PRODUCT CHANGE NOTIFICATION

Product Category COPPER CONNECTORS 20220308-1

Product Group ENTERPRISE CONNECTIVITY

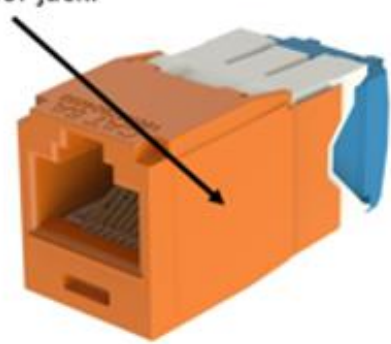
Panduit's Cat 6A UTP Jacks use an aluminum foil tape applied to the jack housing to achieve industry leading alien crosstalk performance. Panduit is making a permanent change to the color of the foil tape on Pan-Net Cat 6A UTP Jacks. The old foil tape was colored similar to the color of the housing. Due to global material shortages Panduit will be providing jacks, independent of housing color, with a silver colored foil tape. This change took place in Panduit's manufacturing facilities in Nov 2021 and will now be permanent. This change does not affect fit, form, function, or jack performance.

See images of the new silver foil tape to the right.

Example below: current color matched tape may be substituted with silver color. This will apply to any color jack.

This shows the new tape color that may be utilized.
